DAIM-ODB-RM

SUBJECT: Explanation of Significant Differences for Basin F/Basin F Exterior Remediation Project, Revision 0

**EXPLANATION OF SIGNIFICANT DIFFERENCES FOR  
BASIN F/BASIN F EXTERIOR REMEDIATION PROJECT  
ROCKY MOUNTAIN ARSENAL FEDERAL FACILITY SITE**

### Figure 1.0-2

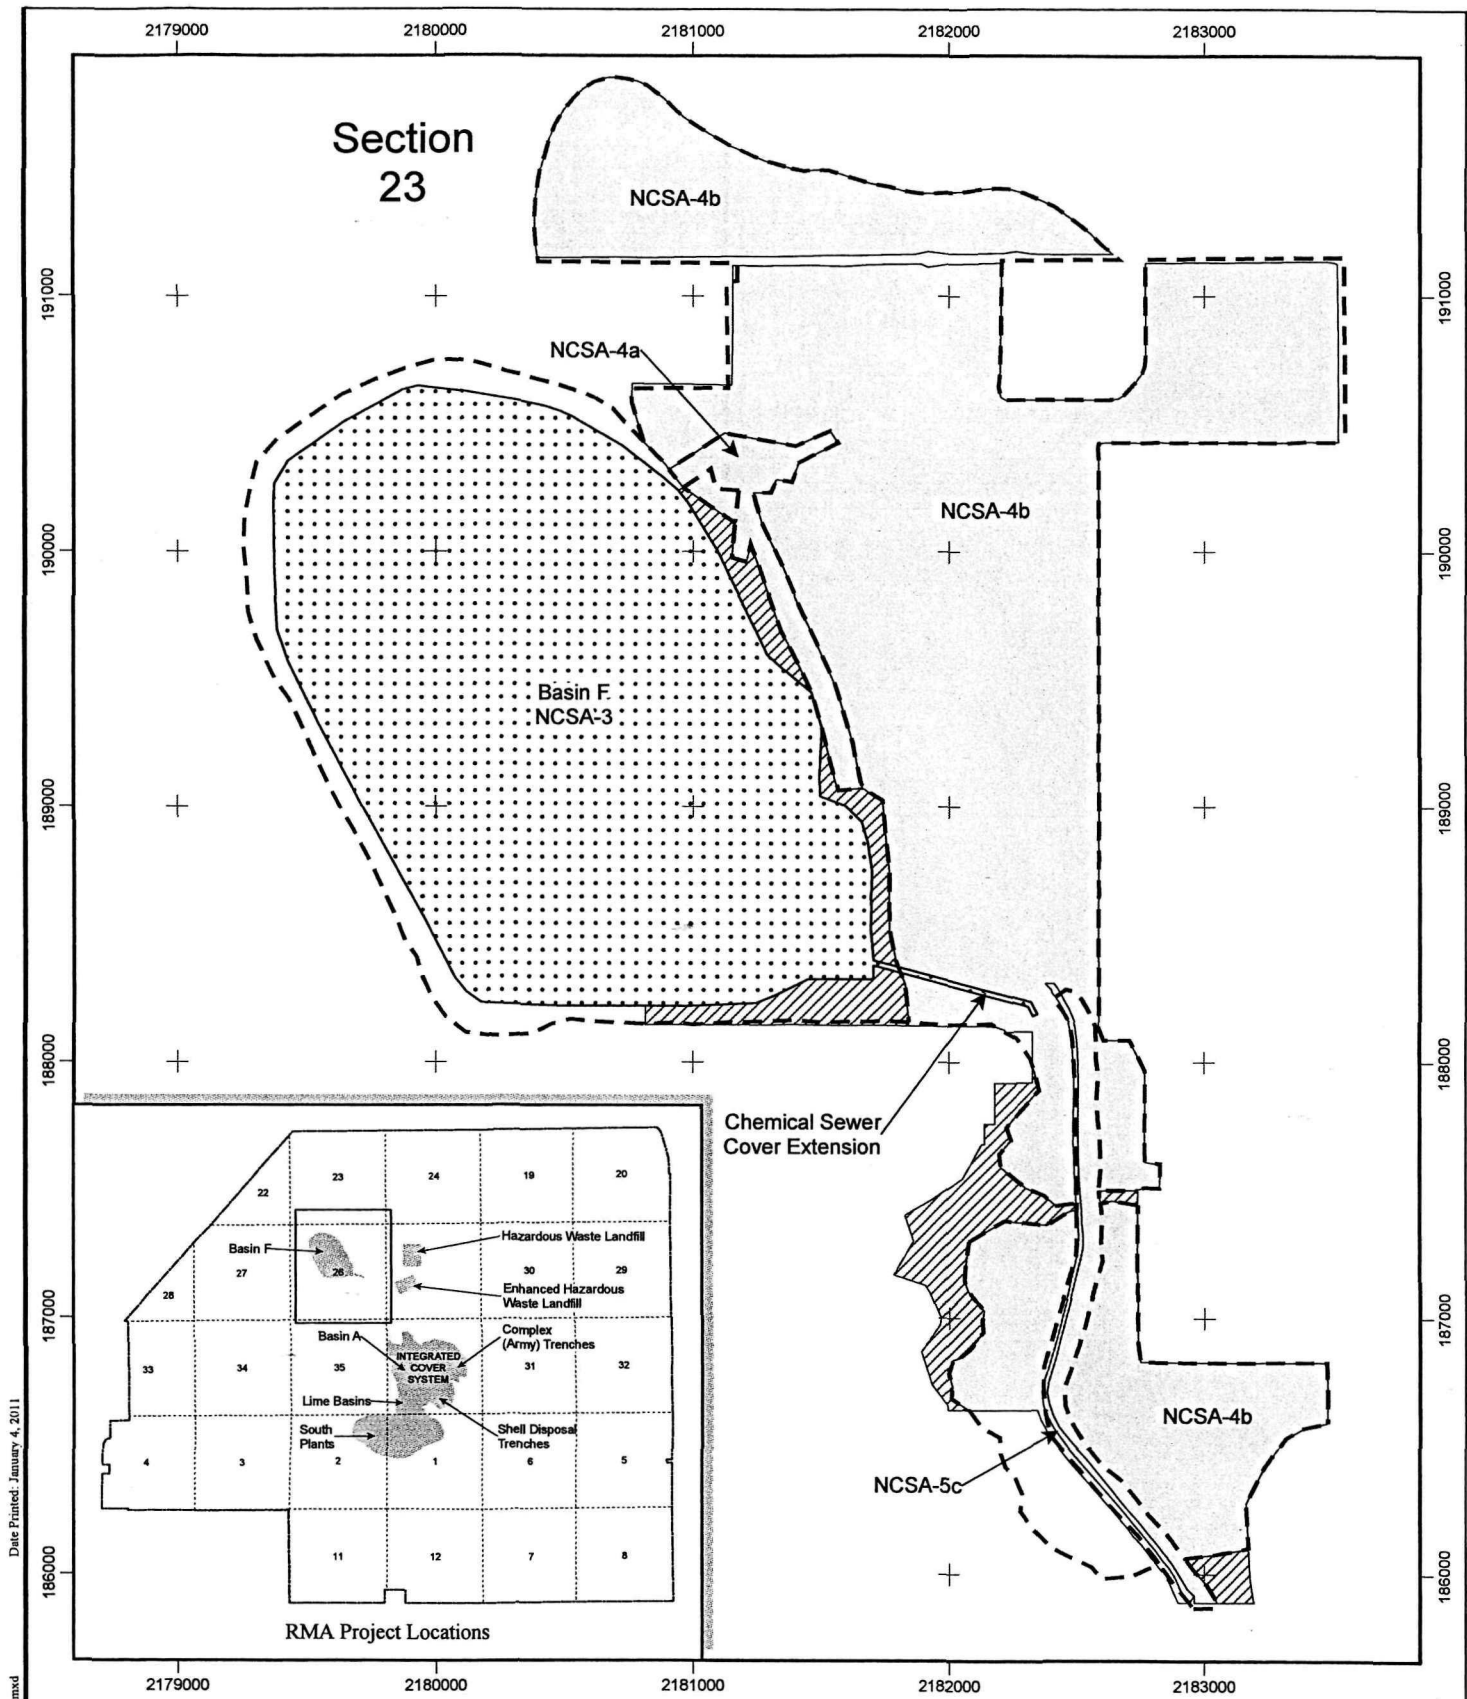
Consistent with remedial actions identified in the ROD for chemical sewers, the remedy was to grout the pipe and construct a RCRA-Equivalent cover over the potentially contaminated soil associated with NCSA-6a (the chemical sewer). The selection of this remedy is described in the *Explanation of Significant Differences for Basin F/Basin F Exterior Remediation Project – Part 2 (Basin F Cover) and Chemical Sewer Remediation* (TtEC 2009a). The presumed contaminated soil limits were defined consistent with the ROD as 2 feet (ft.) below the pipe and 10 ft. laterally on each side of the pipe. The resultant 20-foot-wide RCRA-Equivalent cover limits and 50-ft. BBM runout limits were defined and approved through Design Change Notice (DCN)-BFC-008 in November 2008. The Basin F RCRA-Equivalent cover was extended over the 0.3-acre potentially contaminated soil associated with the chemical sewer (refer to Figure 1.0-2).

The Basin F boundary (i.e., the impoundment/basin area requiring RCRA-equivalent cover) was modified from the ROD boundary. As a result, the Basin F surface impoundment area decreased from the ROD area of 108.2 acres to 92.2 acres.

DCN-BFE-005 made adjustments to NCSA-4b due to the adjustment of the Basin F boundary, described in Section 2.4.1.3. The reduction of the Basin F (NCSA-3) site area resulted in a corresponding expansion of the NCSA-4b area and remediation volumes. Most of the volume increase was HHE soils around the southeast corner of Basin F where design remediation depths of 2 to 3 ft. were designated, resulting in an increase of 17,701 cy.

\* Boundaries shown are a result of changes made as reflected in the design and as modified by DCN during implementation.
